Initial PSC Questions and Staff Responses – Better Housing by Design Proposed Draft

August 31, 2018

VISITABILITY PROTOTYPES STUDY

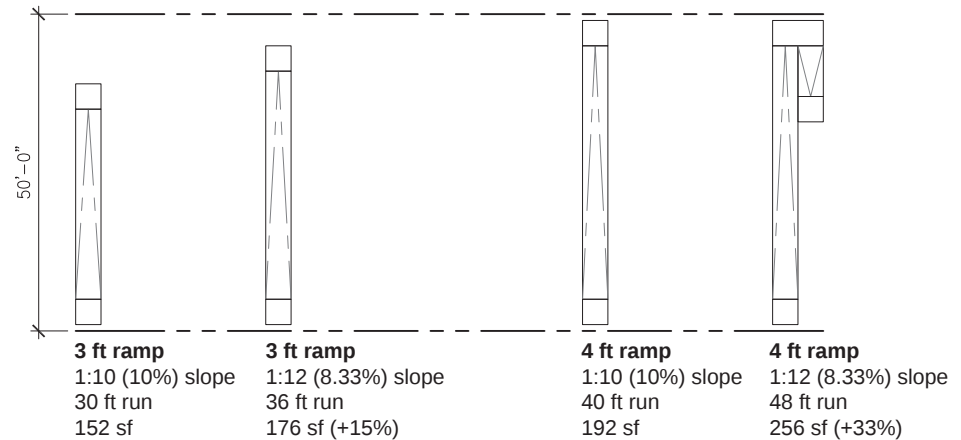
Generally, the impact of visitability requirements (beyond the cost of a ramp) on a site 3 feet above the sidewalk are minimal. As the grade change approaches 4.5 ft, the requirements become more challenging, presenting developers with a choice of utilizing a side ramp configuration which may pose excavation challenges, or a front ramp which will reduce the building footprint, increase the front setback and may lose a unit. Although row house widths on the east coast run as narrow as 12 feet, 17-18 feet is more ideal. In general, a ramp that can be accomplished in a single run across the front of the lot, while still accommodating a stair will have minimal impact on project feasibility (30-35 ft long ramp).

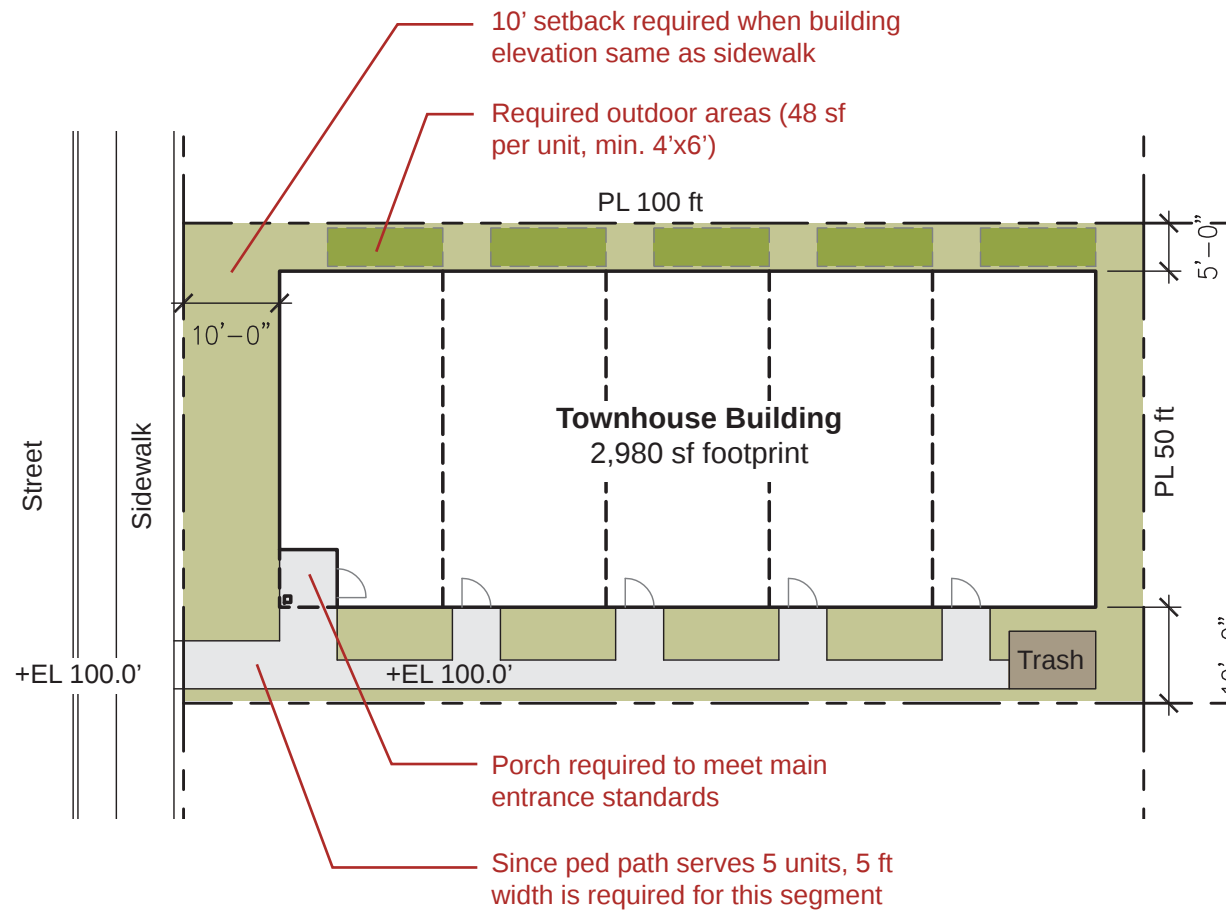
Although a 1:10 (10%) slope ramp is proposed for visitability, a 1:12 (8.33%) slope limitation is a much more common standard carried in the ORSC and the Oregon State Structural Specialty Code (commercial code). The difference in required site area between the two ramp slopes is illustrated in the diagram below.

On small sites where site area is at a premium, the additional space required for a 1:12 ramp instead of a 1:10 will create more challenges in site design. Once the ramp length is long enough to require a switchback ramp, the front setback and building footprint are significantly impacted.

In general, visitability for sites 3-4 feet above grade seems reasonable to achieve. Sites beyond 3.5 ft above grade necessitate a switchback front ramp which starts to impact building area more significantly. Adding provisions to the pedestrian and main entry standards to remove constraints and avoid a redundant stair for these types for sites would make visitability easier to achieve. Reducing the required width for a courtyard entry on a small site to serve as a main entry could help with this. The proposed reduced front setback (from 10' to 5') for elevated lots helps these sites achieve development potential similar to flat sites, except when a front switchback ramp is proposed. Soil type and features on adjacent sites will highly affect the feasibility of any ramping or excavation work needed near property lines.

OPT 4.5b Building elevated 4.5 ft w/ front ramp

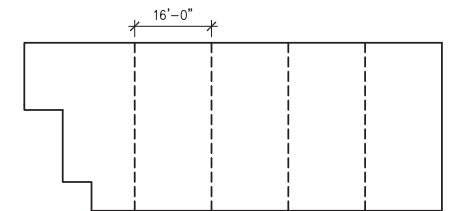
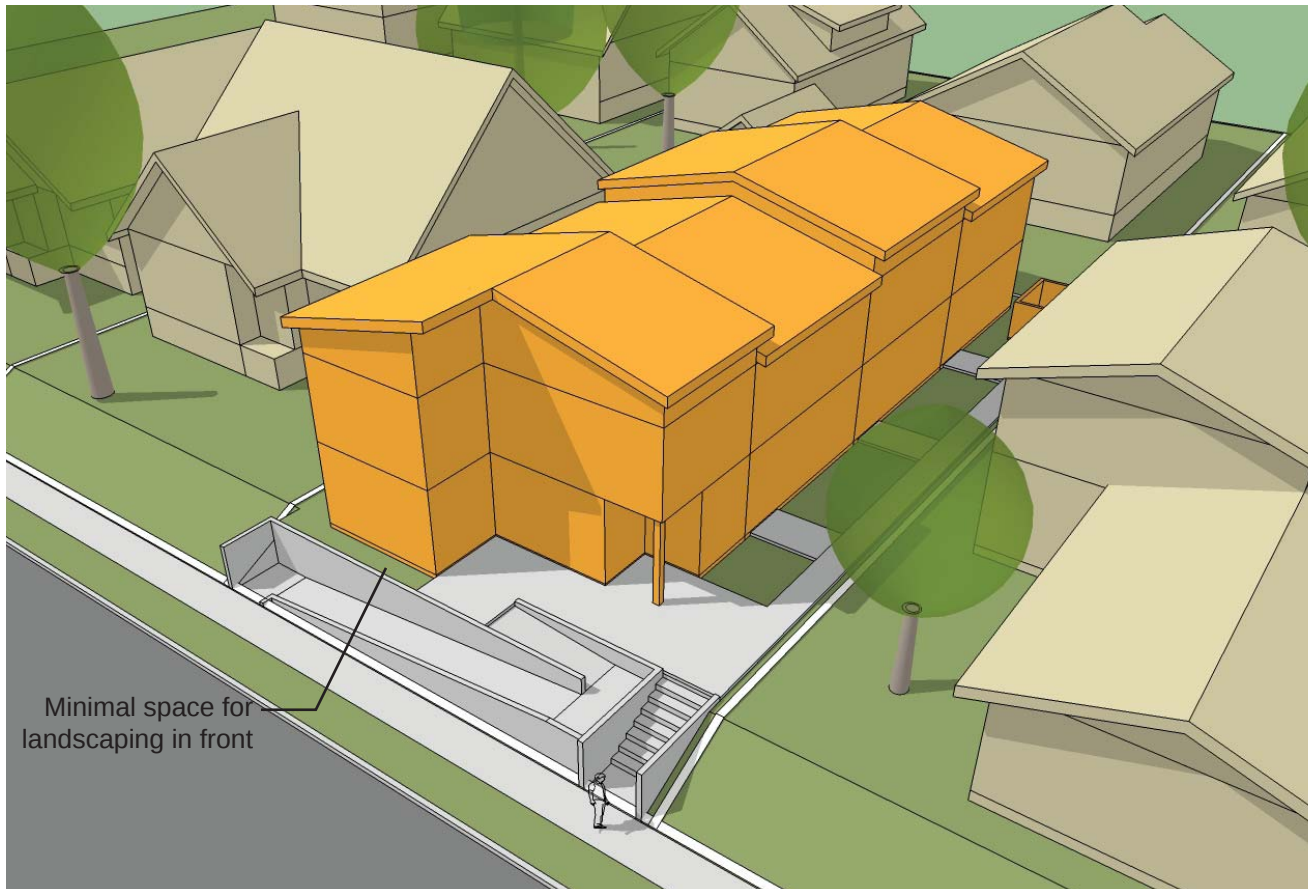
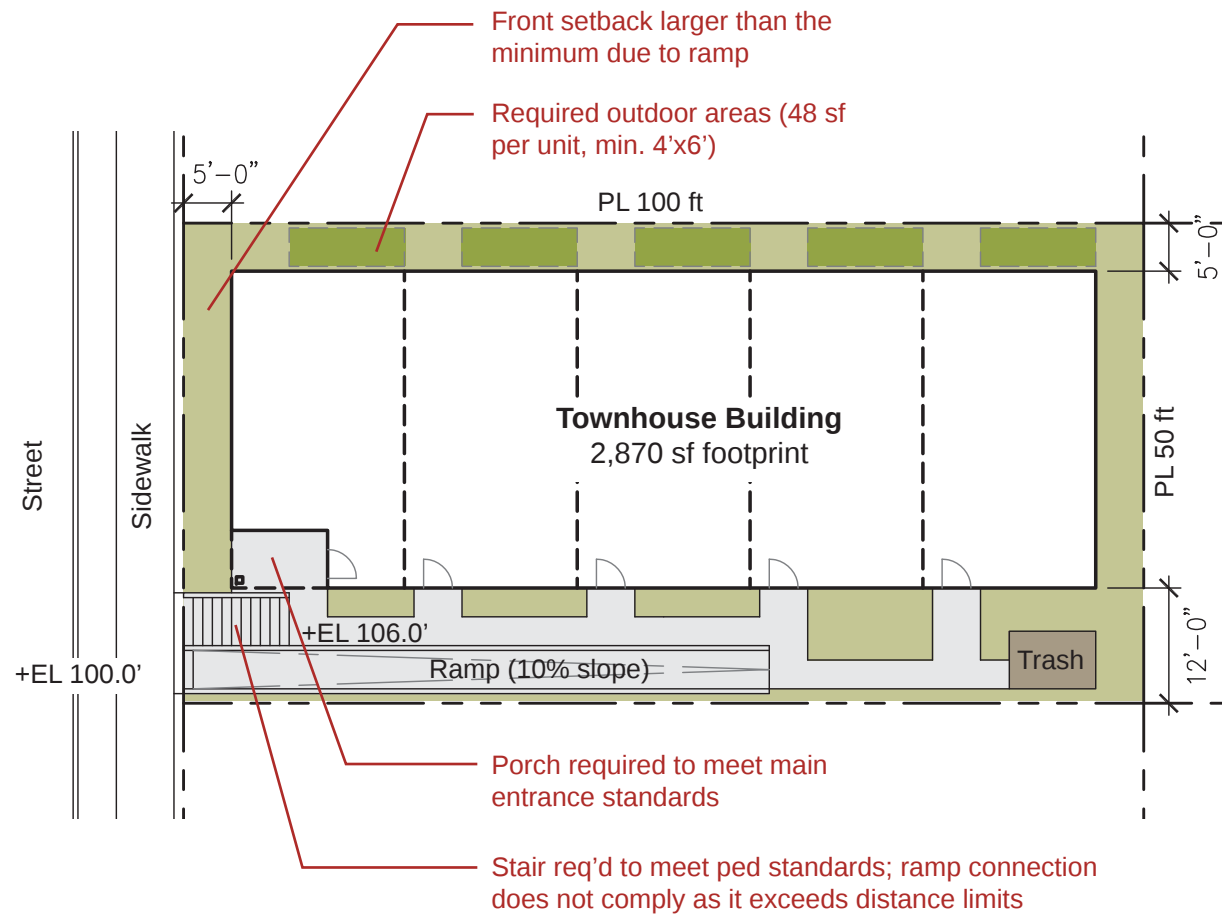
1) Going to 5 units in this configuration will require sub-16 foot widths for rowhouses, which may be less than ideal.

OPT 6a Building elevated 6 ft w/ side ramp

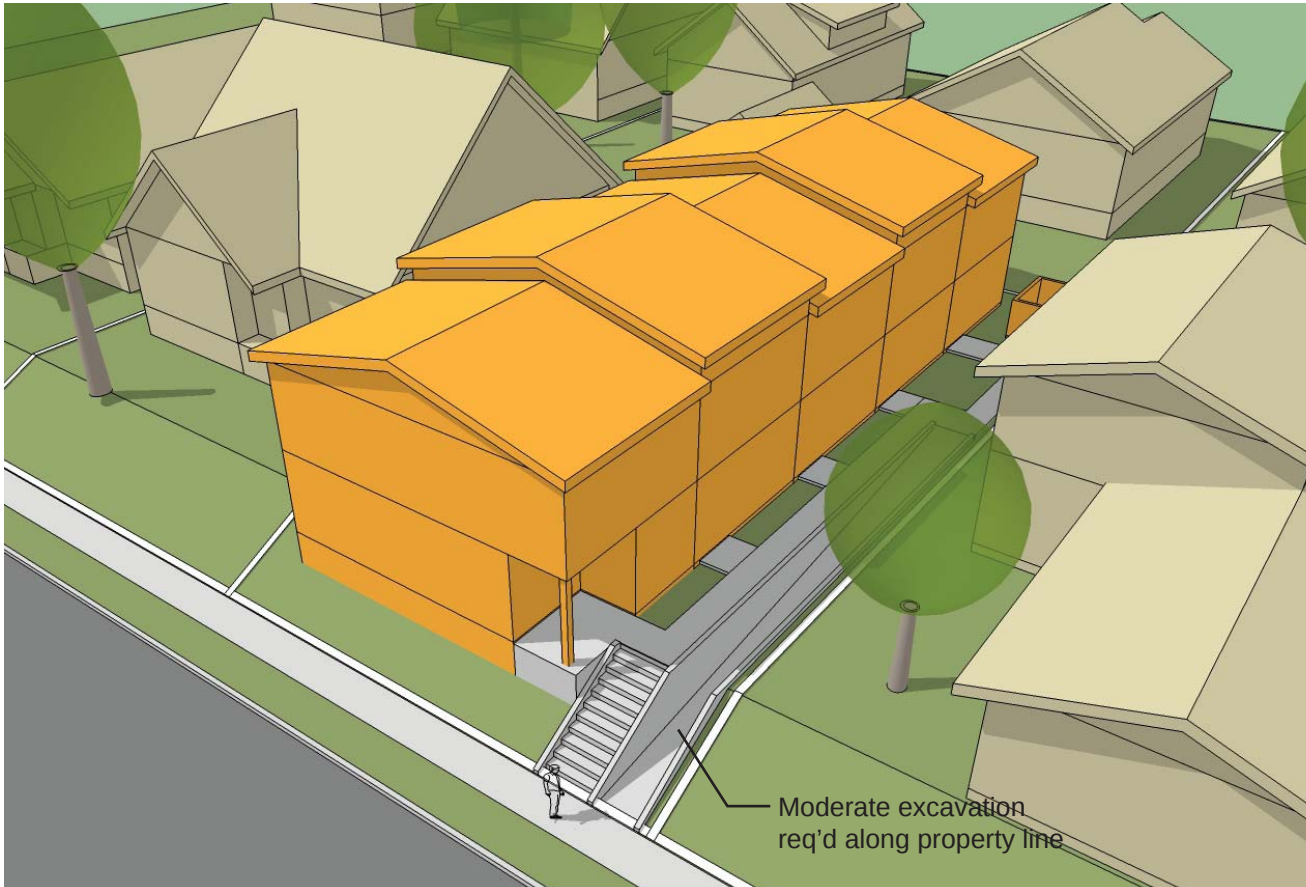
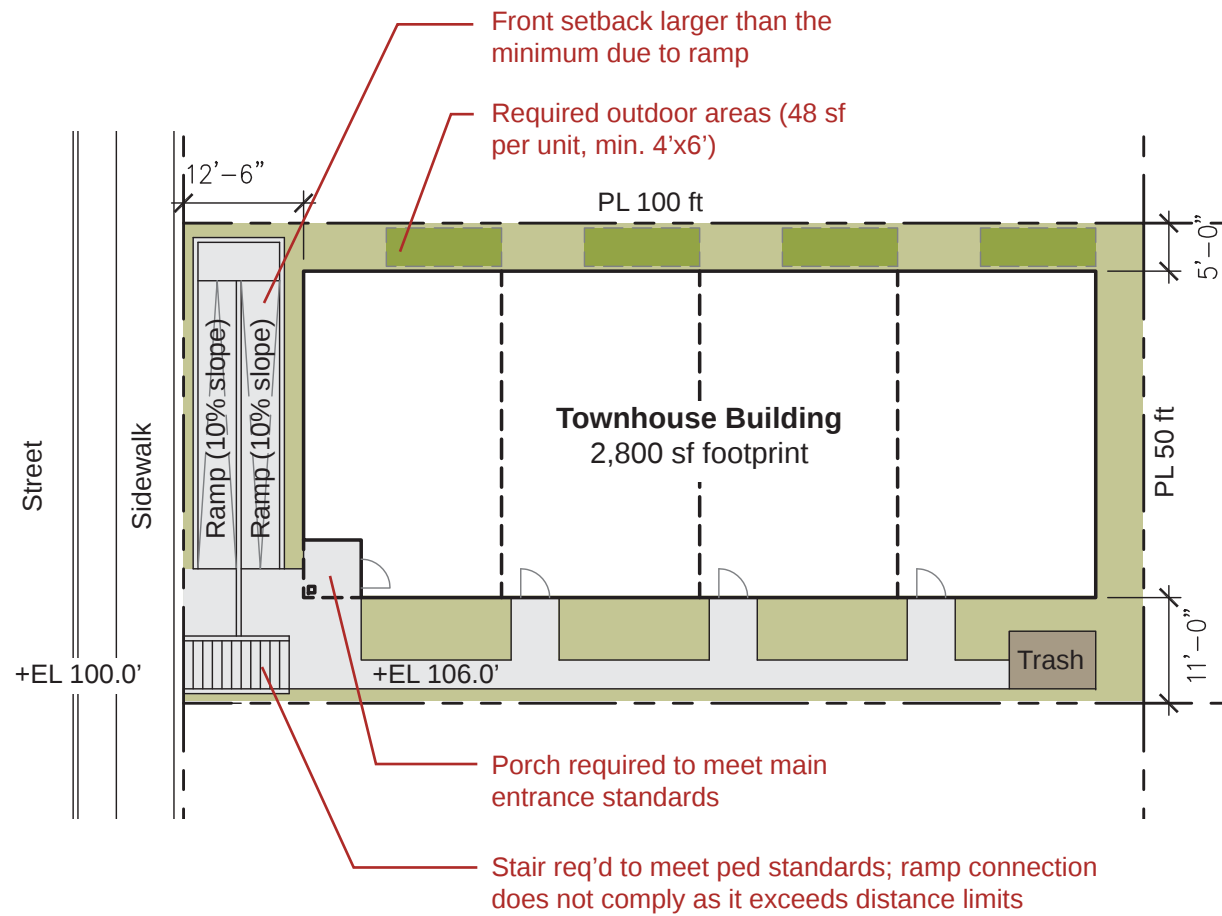
1) Traversing 6ft of grade at 10% requires a 60 ft long ramp. In this scenario, a single run of ramp may be difficult for many wheelchair users to navigate without an intermediate landing.

OPT 6b Building elevated 6 ft w/ front ramp

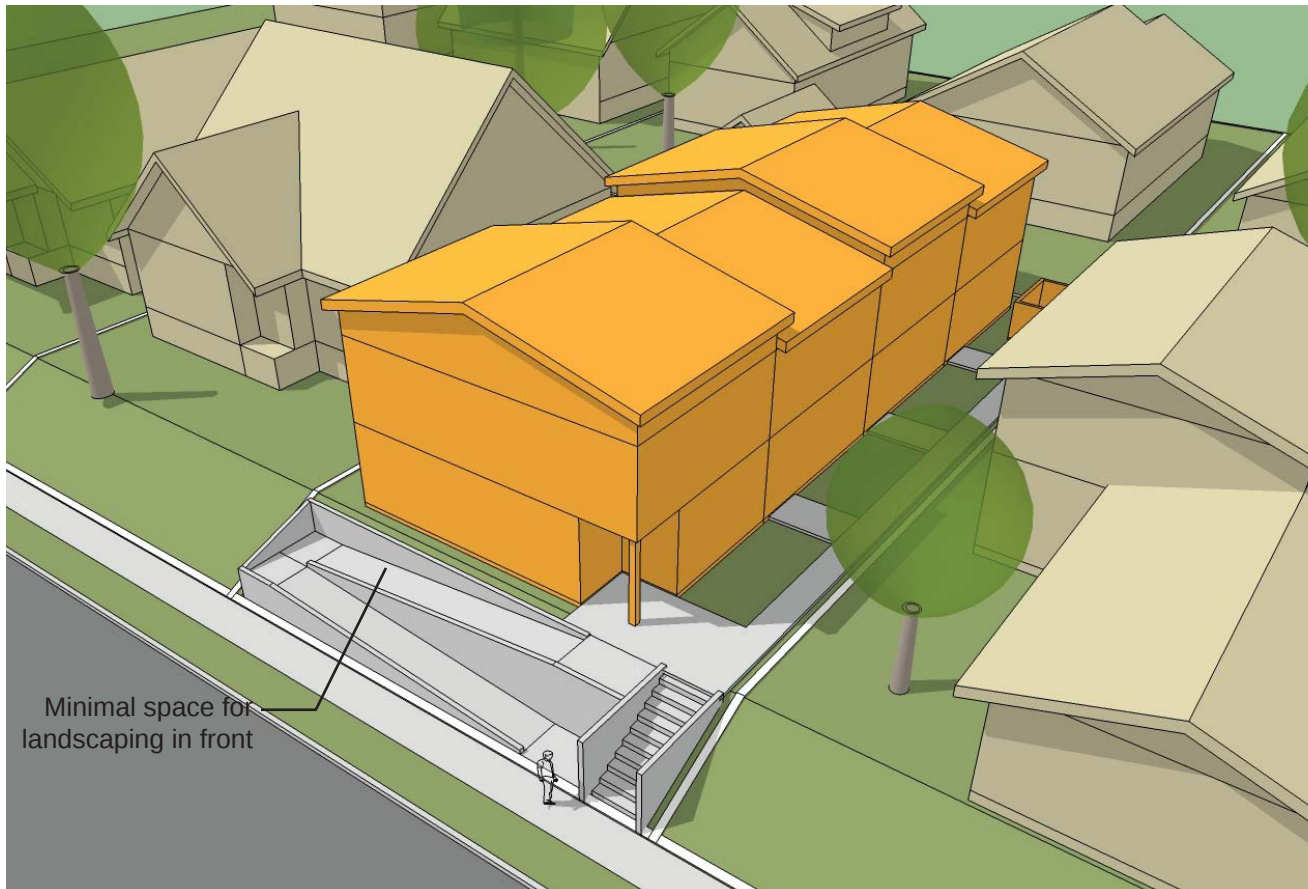
Minimal space for
landscaping in front
